## **COMMISSION OF ARCHITECTURAL REVIEW REGULAR MEETING AGENDA**

**July 24, 2025**

# STAFF REPORT

DATE: July 24, 2025  
TO: Commission of Architectural Review  
FROM: Renee Burton, Division Director of Planning  
RE: Certificate of Appropriateness application PZ25-00333 filed by Andrew Magness to replace and repair hidden gutters Parcel 55650 (134 Sutherlin Ave.).

## Hidden Gutter Replacement

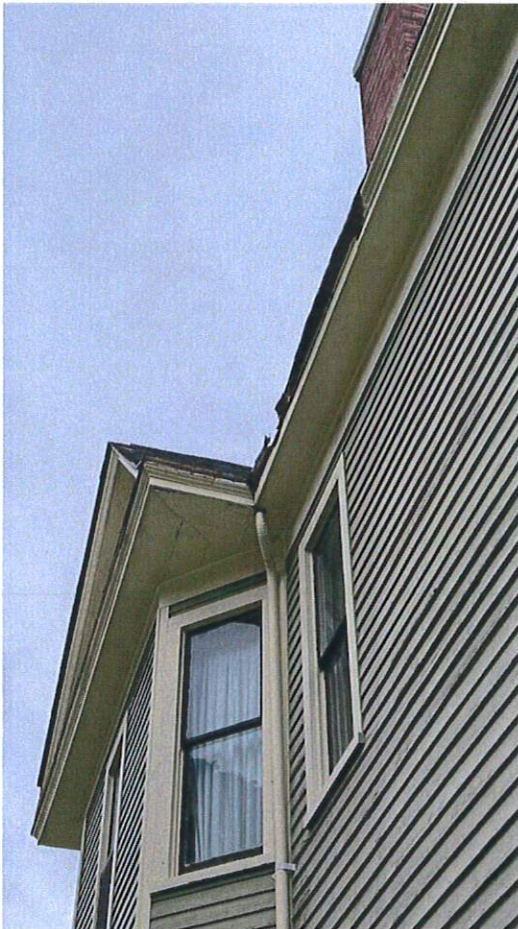
The applicant proposes to replace the existing hidden gutters with new half-round gutters and to install a downspout on the front porch. According to the applicant, the existing gutters are deteriorated, and a downspout has been recommended to address recurring issues with standing water.

The replacement gutters should be installed in a manner that minimizes visibility. Exposed gutters should be painted or finished to blend with the structure.

Best Barns 12x16 Hampton Wood Storage Shed Kit (hampton1216)

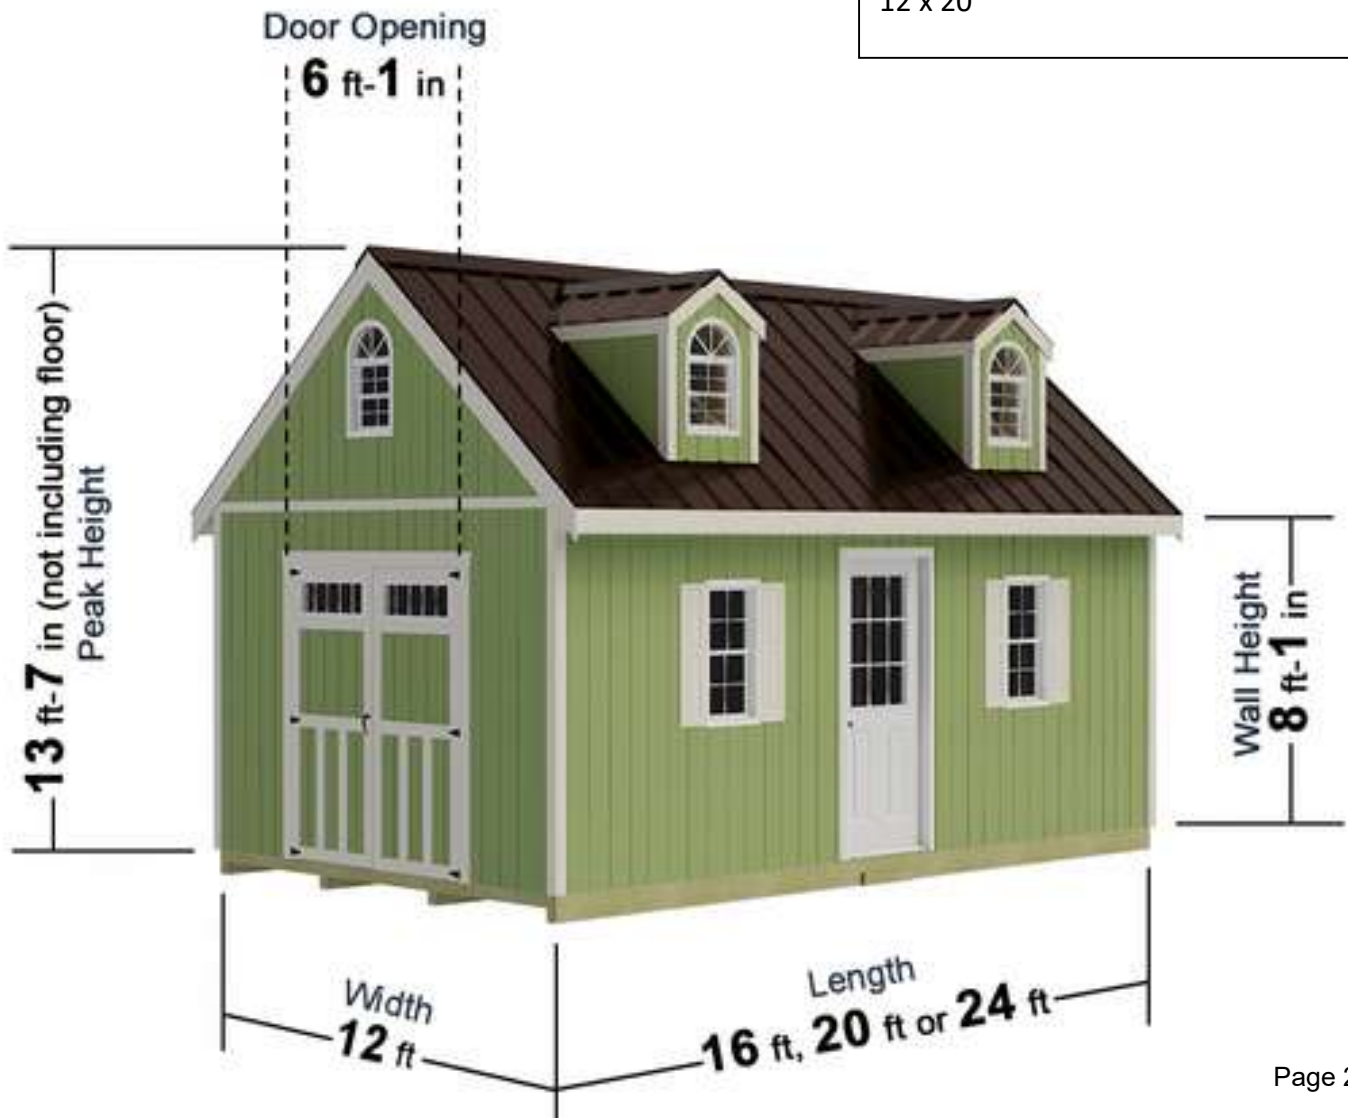
The applicant proposes to construct a 12-foot by 20-foot shed at the left rear corner of the property at 141 Holbrook Avenue. The proposed shed is a prefabricated wood kit with a gable roof with asphalt shingles painted to match the main house, and features vertical panel siding. The shed meets placement and scale requirements in the Old West End Design Guidelines and the roof form is appropriate. However, the panel siding does not reflect the shingle siding of the house.

-The shed should be painted in a color to complement the primary structure.

# Standard Aluminum Fencing

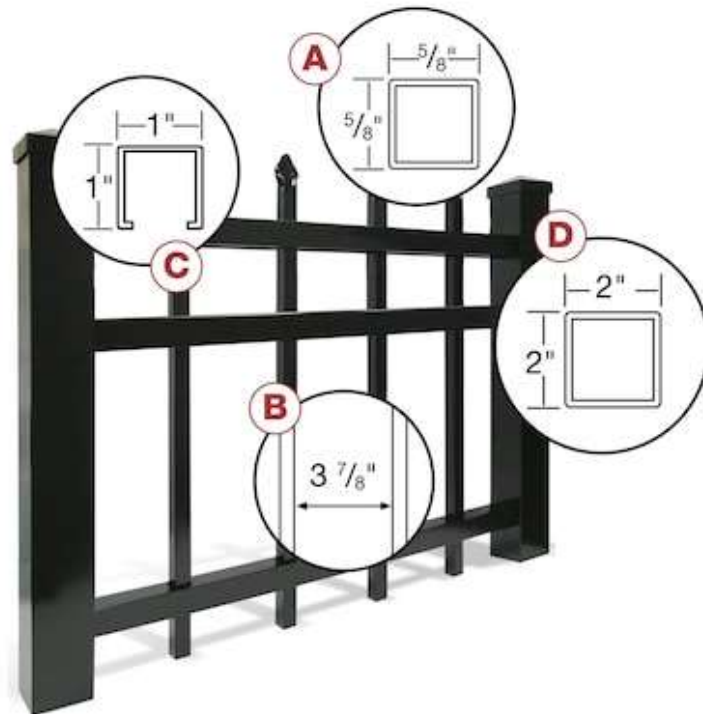
The applicant also proposes to replace the existing wire fencing along the left and rear property lines with a 54-inch-high black aluminum fence featuring a flat top and three horizontal rails. While wood and wrought iron are the preferred materials under the design guidelines, aluminum is not explicitly prohibited and may be acceptable in the rear yard where utilitarian fencing is allowed.
